LEBO CREEK MASTER DRAINAGE STUDY FINAL REPORT

Job Number: 19-023

September 20, 2022 (Amendment No.1)

AMENDMENT NO.1

drawn by date	EMK SEP 2022	project no. 19-023
designed by date		figure no. A-3
checked by date	ADM SEP 2022	scale 1:40,000

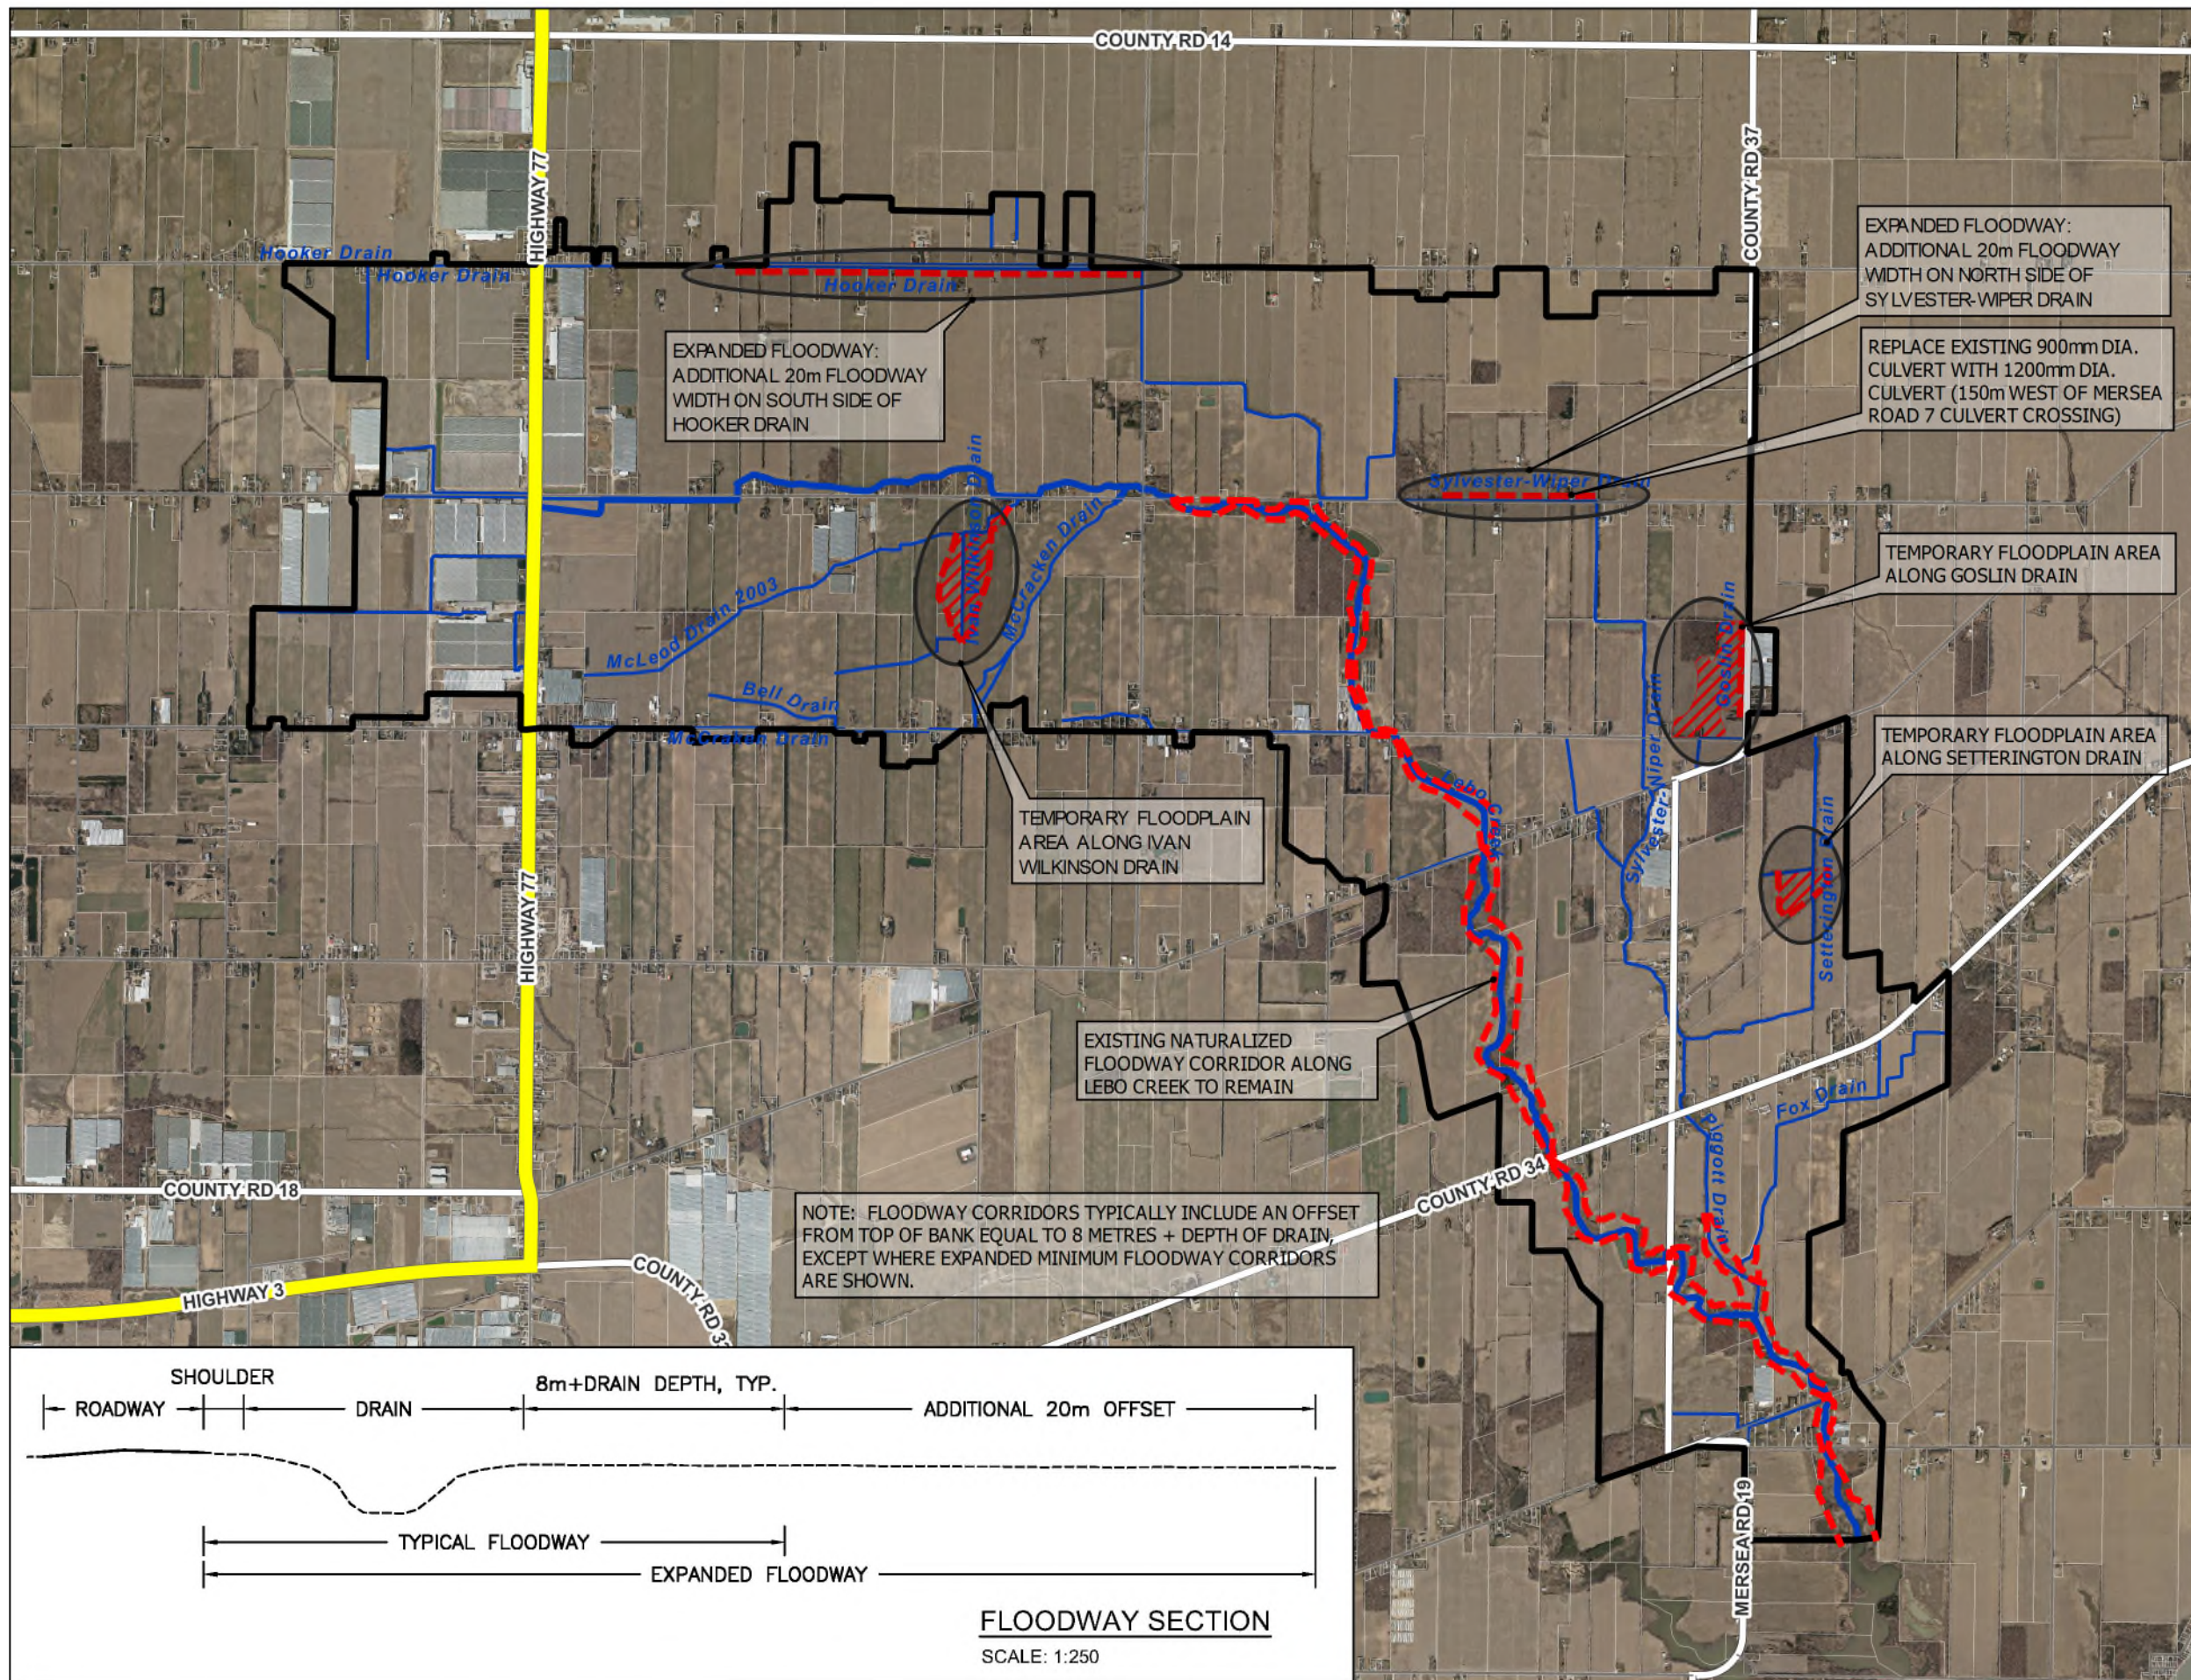
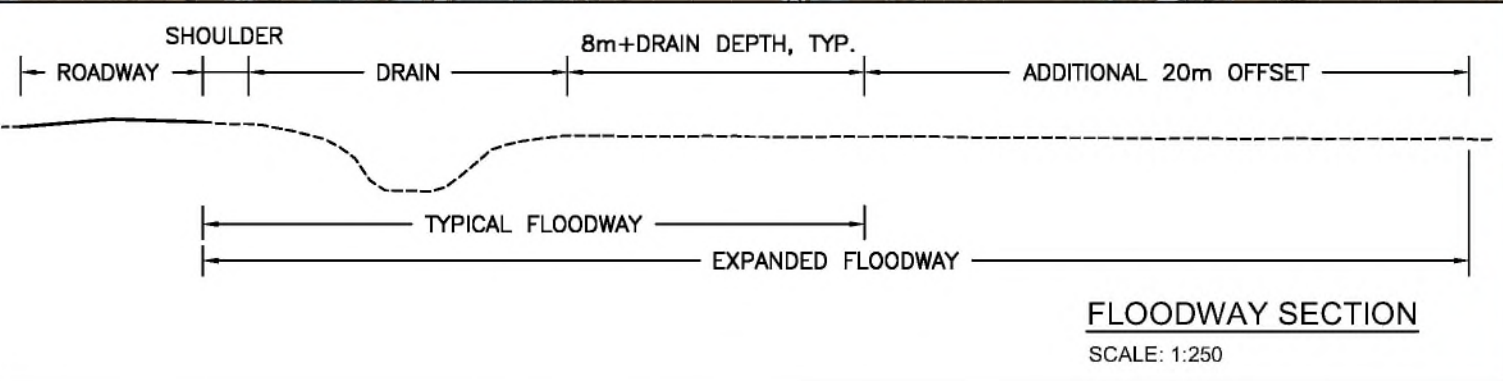
1. *Figure A-3 and associated maps in Appendix E:* Identify “temporary floodplain areas” in lieu of the “existing floodplain storage” and “concept floodplain storage”. Affected flood elevation maps (E-9, E-12, E-25 to E-27) have also been revised to reflect these changes.
2. *Section 2.1.3:* Additional discussion included to clarify the specified 25% buildout limit and future development conditions.
3. *Section 3.2:* Revise “Other Areas” to “Outside of Service Area”.
4. *Section 4.1:* Revise discussion regarding floodplain areas and potential ERCA setback requirements.
5. *Section 4.1.1:* Revise discussion regarding measures related to long-term function of the SWM ponds.
6. *Section 5.2:* Revise recommendation item 7 to suit revised section 4.1 and clarify conditions of temporary floodplain areas.
